2.4.2 Response to Item No. 4 (2)

We trust that this submission fully addresses the *Request for Further Information* in respect of the subject development at a site known as Block R, Jordanstown Road, Aerodrome Business Park, Rathcoole, Co. Dublin.

Figure 2.7: Landscape Masterplan (Drawing No.: FDJ-JBAI-XX-XX-DR-L-0002)

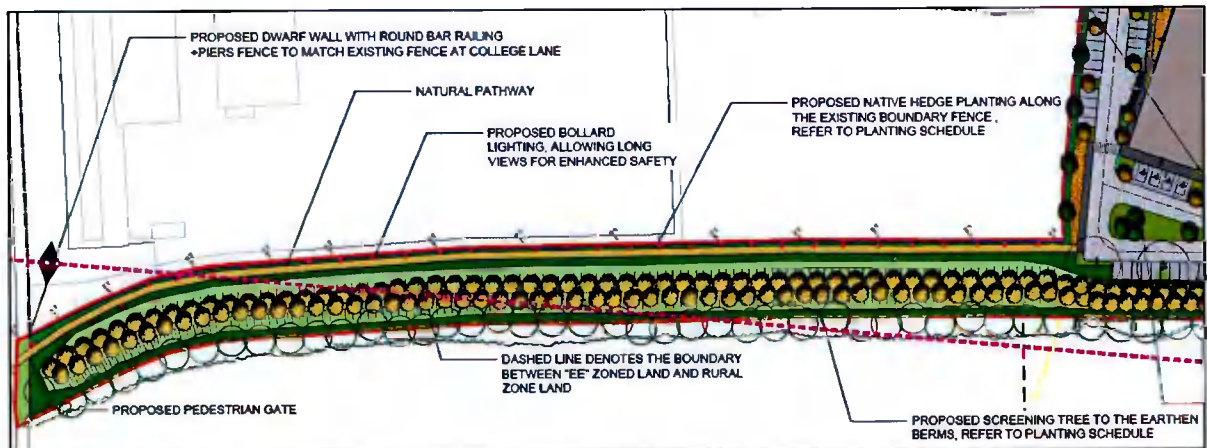
'With reference to the lands Zoned Rural the applicant is requested to submit:
 (i) *revised proposals to increase the proposed planting along the southern elevation (within the rural zoned lands) alongside the new pathway/cycleway and existing hedgerows should be augmented (to provide for Green Infrastructure in compliance with Chapter 8 of the CDP and to provide a significant planted buffer at this transition area (from industrial to rural).*
 (ii) *Drawings of how this pedestrian/cyclist entrance will appear from the roadside should be submitted for a full assessment to take place; these should include (but not exhaustive) elevational plans and landscape plans at the R120 interface.'*

The southern, eastern and northern boundaries of the proposed development will be provided with a dense planted transition strip creating a strong boundary between the adjoining agricultural lands and the subject warehousing facility. In particular, the southern boundary has been given specific attention by the Design Team as dense planting and raised earth berms have been provided to soften the transition line. As part of this *Response to Request for Further Information*, the southern boundary landscaping strip has been increased to provide a consistent 10m zone forming the transition from the 'EE' zoned lands to the rural lands to the south.

An extract from the Landscape Masterplan prepared by JBA Consulting has been provided below which includes annotated measures proposed to address the concerns of the Planning Authority along the southern boundary:

Figure 2.10: Extract from the Previously Proposed Site Plan (Left) and the Now Proposed Site Plan (Right)

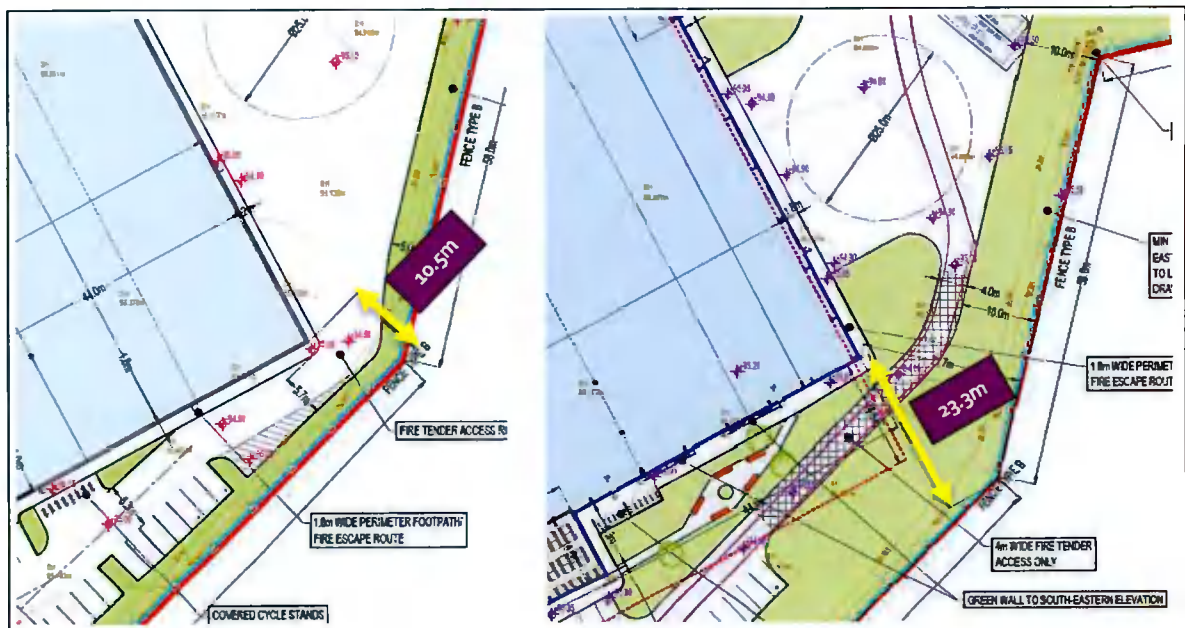
(i) increased mitigation measures should be proposed, this should include the relocation of the structure away from the southern boundary in a northerly direction and the inclusion of a green wall/green façade on the southern elevation (which should be redesigned).

Extracts from the Previously Proposed Site Plan and the Now Proposed Site Plan have been included below which show the relocation of the proposed warehouse structure away from the southern boundary in a northerly direction to afford a greater transition to adjacent rural zoned land. An increase in the distance from the southern boundary is noticeable with an increase from 10.5m to 23.3m proposed.
